Addendum No. 06

File Reference Number: RFP 2025 035

Title: Iroquois Falls Subdivision Track Rehabilitation

RE: Clarifications/Questions

TITLE:
ONTARIO NORTHERN
115RE #8 STRAIGHT SPLIT,
RIGHT HAND, PANDROL TURNOUT
15'-0" SAMSON SWITCH, RBM FROG

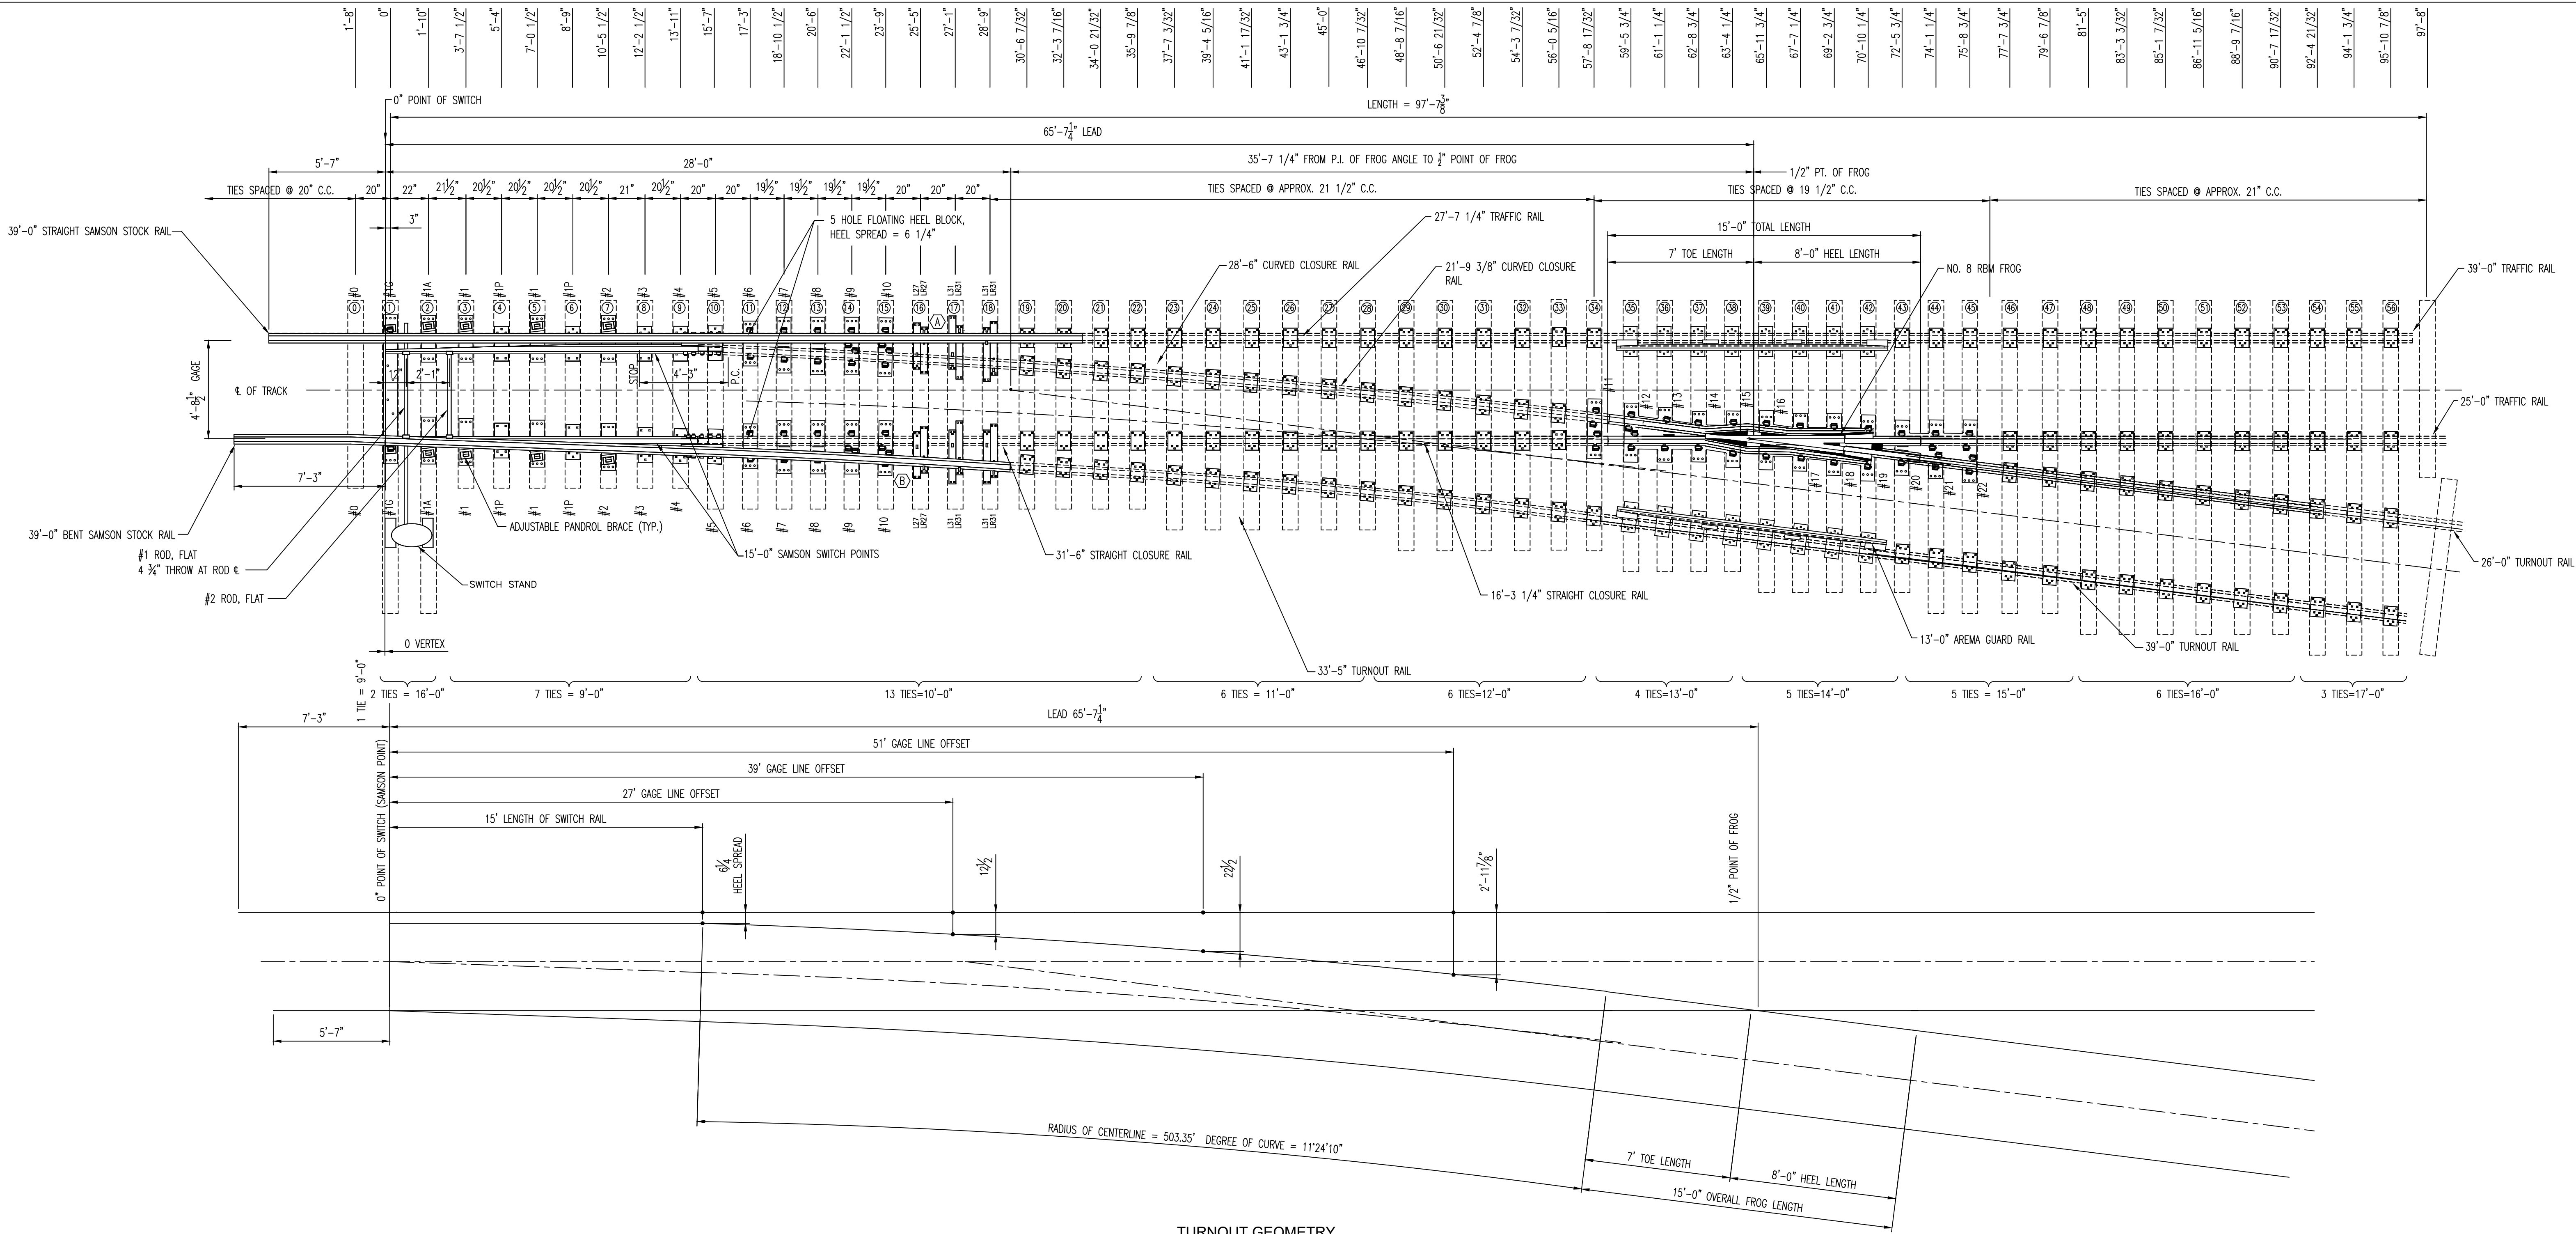
Item 2: Please confirm that there is no requirement to redesign the horizontal track alignment to accommodate the new Turnout Installations.

Item 3: Please confirm the location of each new Turnout within the yard limits. Please confirm the switch geometry, rail weight and total length of each switch.

Answer: Please see attached turnout drawing for your reference at Addendum A. These turnouts will be installed as part of the turnout replacement plan of this project.

Answer: ONTC will share the new turnout locations with the successful proponent. Please see attached turnout drawing at Appendix A.
